**COMMENTS ON
REVISED REPORT**

Comments on revised Comparison report. 30 Aug 02 Steve Maynard

Figure 22. Hypothetical Model vs Prototype

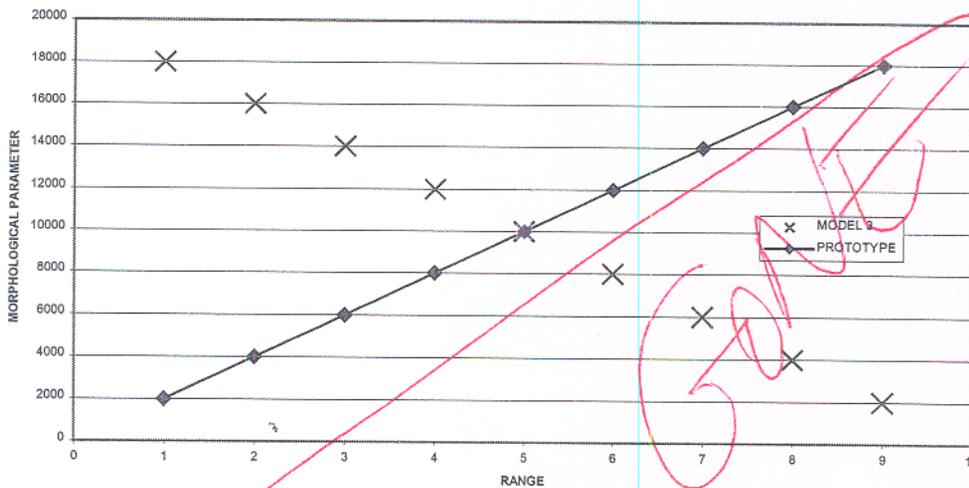
8. Page 2-13-CF plots

The problem I have with the CF approach is shown in the above graph. I think we would all agree that the above model and prototype do not agree. However, the CF plot would show perfect agreement of model and prototype. The CF 50% values and plots need to be omitted.
